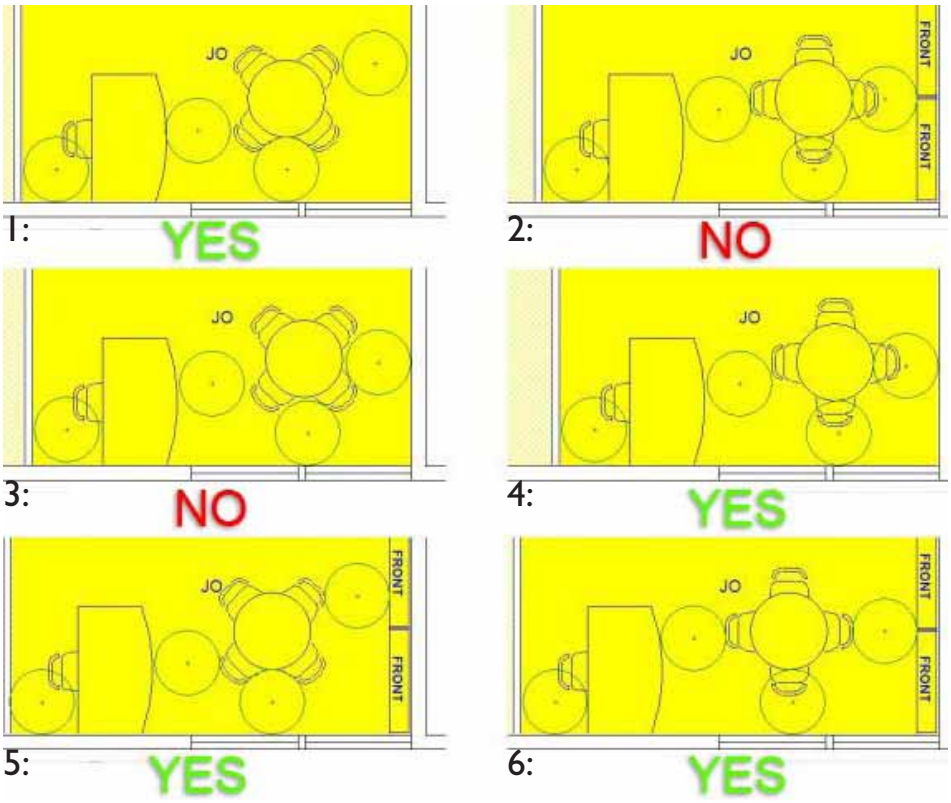
1: Correct because clear 36" path between all furniture elements and between furniture and walls to access all seats.

3: Wrong because 36" should be provided to gain access to the SE chair. The NE chair blocks this path. Could work if table was nudged N to provide 36" between wall and seat edge.

5: Correct because there is a clear 36" path to each seat. 36" between furniture elements.

2: Wrong because 36" between furniture elements was not provided (chair & book shelves)

4: Correct because there is a clear 36" path to each seat. NOTE the similarity to #2. But 36" must be provided between two furniture elements &/or between table edge and wall. Same goes for the executive desk configurations when adjacent to a credenza element.

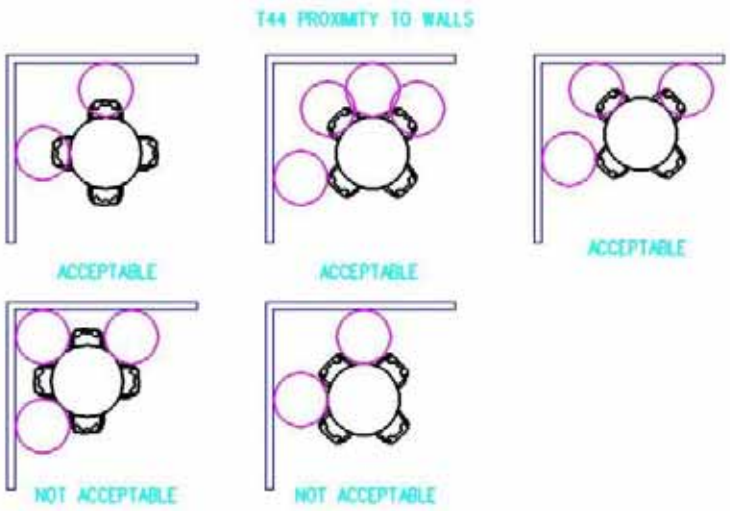
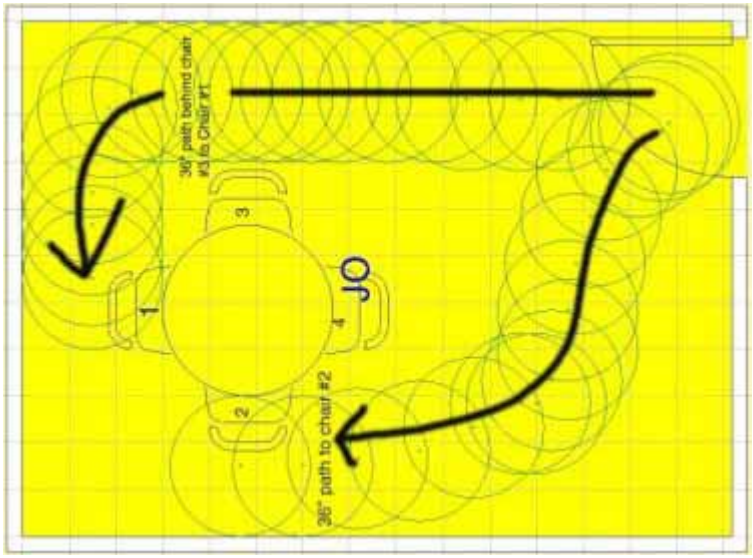
6: Correct because 36" clear between two furniture elements which provides access to the S chair. S edge of table is 36" clear to wall.
